SUNDRY NOTICES AND REPORTS ON WELLS

OXY Bounder #1
Federal

**OXY USA WTP LP - Proposed
OXY Bounder Federal #1
API No. 30-015-34244**

RE: Plug and Abandonment Conditions of Approval

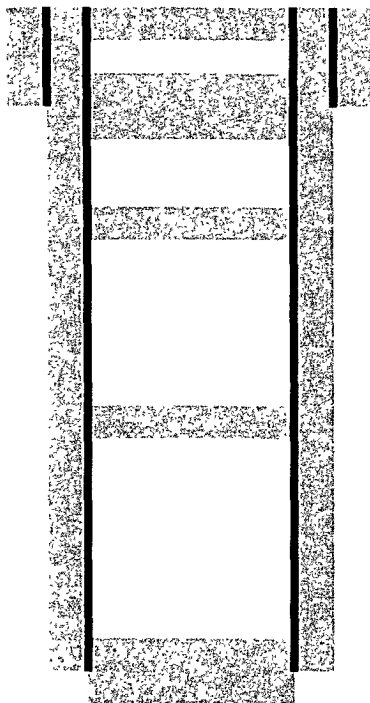
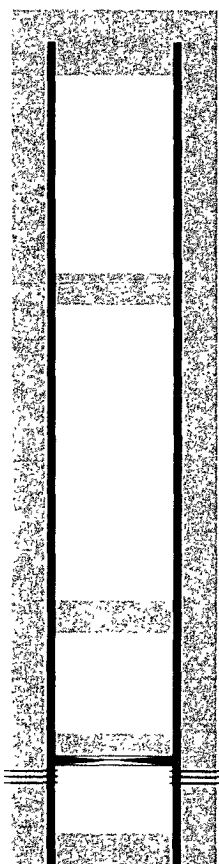
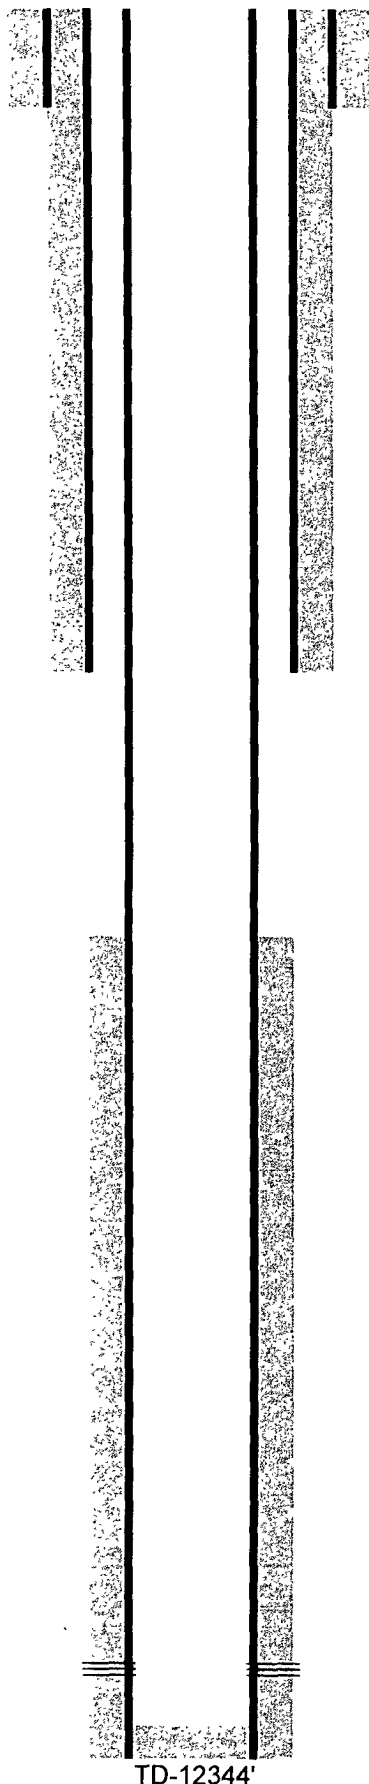
1. No change
2. All plugs require adequate cement to cover 100' plus 10% per 1000 feet of depth.
Set a 200' plug from 11,000' – 10,800'.
3. Set a 180' plug from 8,400' – 8,220'.
4. No change
5. Set a 160' plug from 6,850' – 6,690'. WOC and tag no lower than 6,690'.
6. Set a 140' plug from 4,590' – 4,450'. WOC and tag no lower than 4,450'.
7. Set a 130' plug from 3,295' – 3,165'.
8. Set this plug across the base of the salt from 1,625' – 1,575'.
9. Set this plug to cover both the surface casing shoe and the top of the salt from 818' – 586'. WOC and tag no lower than 586'.
10. No change

Review procedure, if you have any questions, feel free to call. Resubmit Sundry reflecting these minimum requirements.
